## FEDERAL COMMUNICATIONS COMMISSION

In re: WOBO (FM), Batavia, OH

Application File No: BPH-20070122AKE

On January 22, 2007, Educational Community Radio, Inc. and First Broadcasting Capital Partners, Inc. submitted contingent applications for WOBO (FM) and WAOL (FM), respectively. The WAOL application proposes to change that station's community of license from Ripley, OH to Amelia, OH, and change the station's transmitter site by 51.4 km. To accommodate this proposed change, IF channel station WOBO proposes to change transmitter site by 15 km and alter its directional antenna pattern. However, The President and Trustees of Miami University, licensee of noncommercial educational station WMUB, Oxford, OH, has filed a petition to deny against the WOBO application on the grounds that prohibited contour overlap would be created. Because a petition to deny does not lie against a minor change application, the petition to deny will be treated as an informal objection.

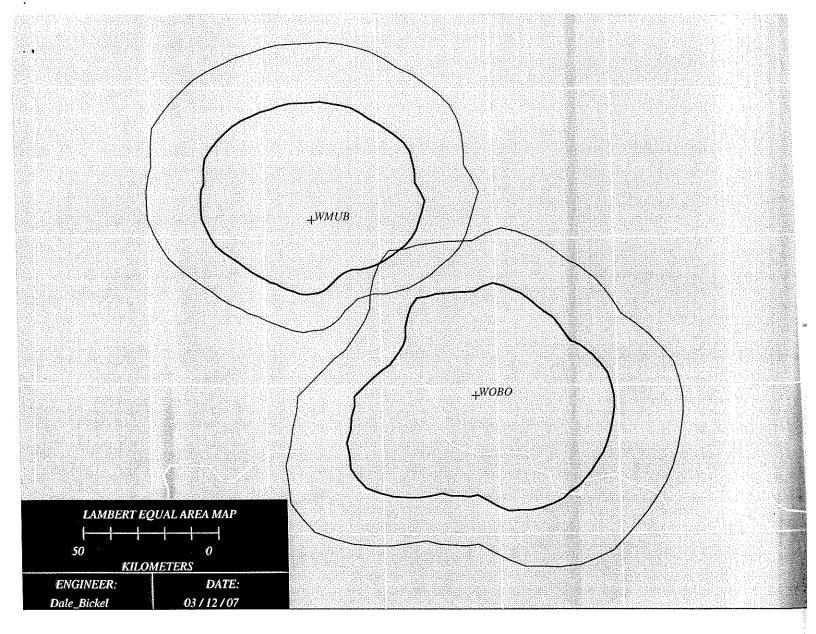
The University's pleading points out that the proposed 54 dBu interfering contour of WOBO will impermissibly overlap the existing 60 dBu of WMUB, in violation of Section 73.509. With respect to first-adjacent channel station WEKU, Richmond, KY, the University finds that prohibited contour overlap would occur between WOBO's proposed 60 dBu contour and the existing 54 dBu interfering contour of WEKU. The University also alleges deficiencies in the WOBO showing of compliance with Section 73.525.

We agree with the University's conclusions regarding WMUB and WEKU. Our analysis gives the same results, and using different terrain databases did not eliminate the prohibited contour overlap. We conclude that the WOBO application is in violation of Section 73.509 with respect to WMUB and WEKU, and the WOBO application is therefore unacceptable for filing.
